**STATE OF NEW HAMPSHIRE**  
**BRIDGE DESIGN MEMORANDUM**

**SUBJECT:** Design Memorandum 2022-02  
NHDOT Precast Concrete Soundwall

The Bureau of Bridge Design is updating the Bridge Design Manual. During this process, certain design decisions are being issued for immediate implementation. Consequently, the Bridge Design Manual, Bridge Details, and Bridge Detail Sheets have been modified as follows:

- Precast Concrete Soundwall (Sheets 1-4)
- Retrofit Precast Concrete Panel, Soundwall (1 Sheet)

SUBDIRECTORY	DGN LOCATOR	SHEET SCALE
English/SNDWALL	SOUNDWALL (2 OF 4)	AS NOTED

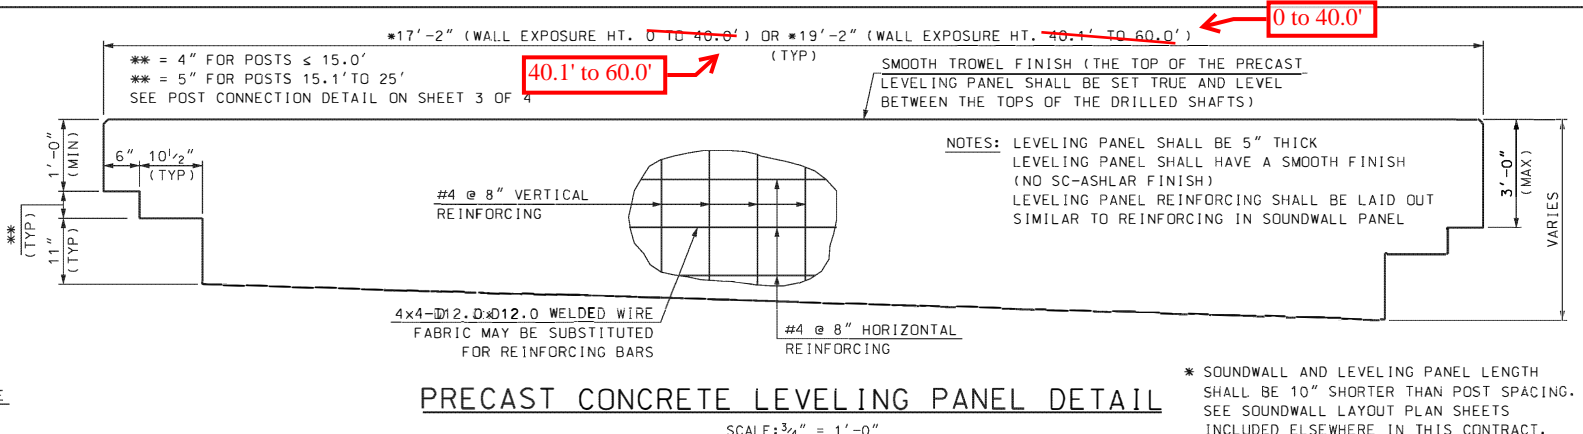
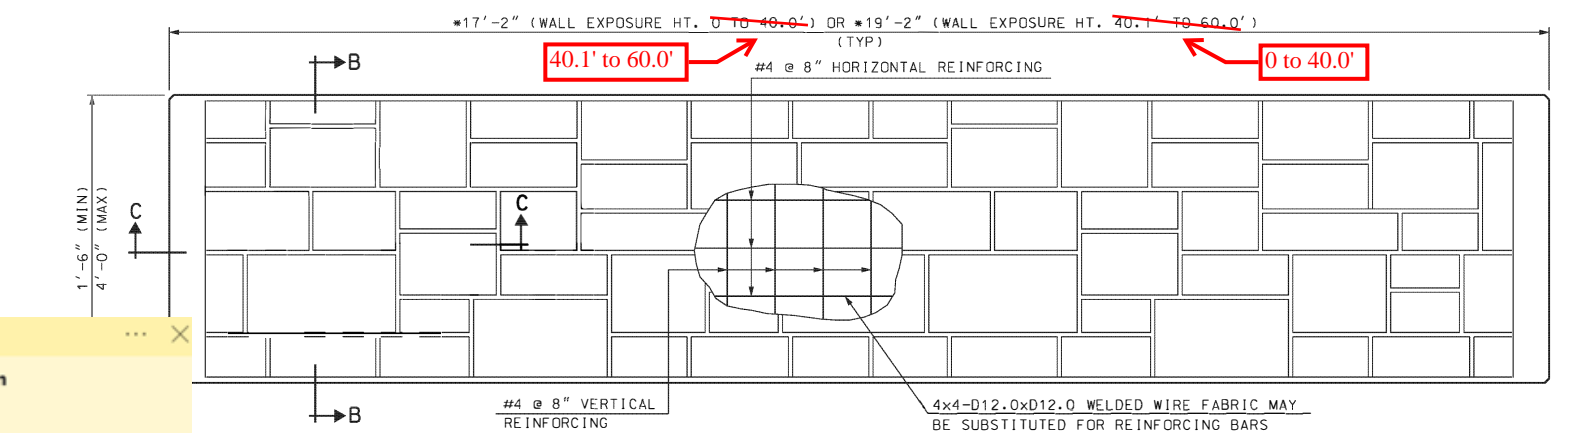
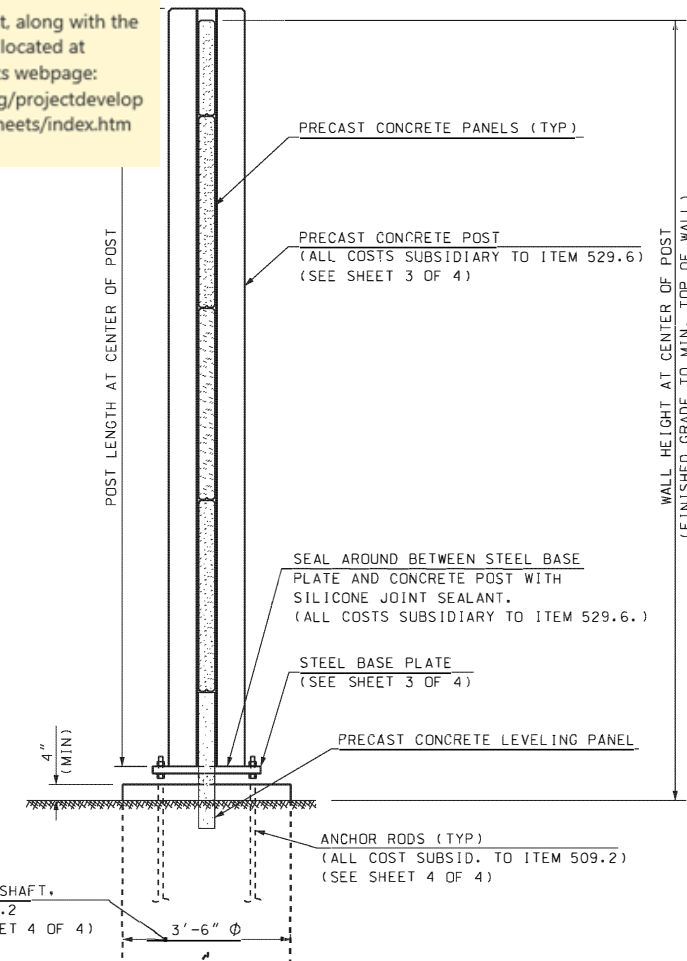
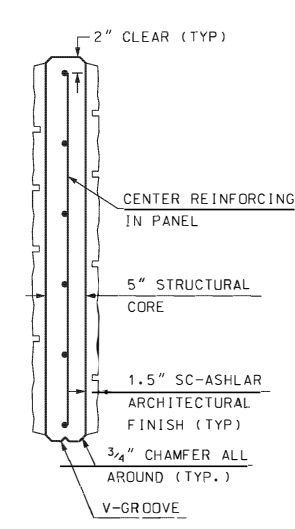
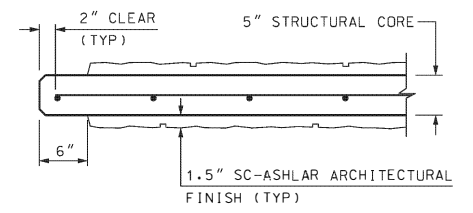
Revisions, noted in red, have been made to this sheet. The revised soundwall sheet, along with the other soundwall sheets are located at NHDOT Bridge Detail Sheets webpage: <https://www.nh.gov/dot/org/projectdevelopment/bridgedesign/detail sheets/index.htm>
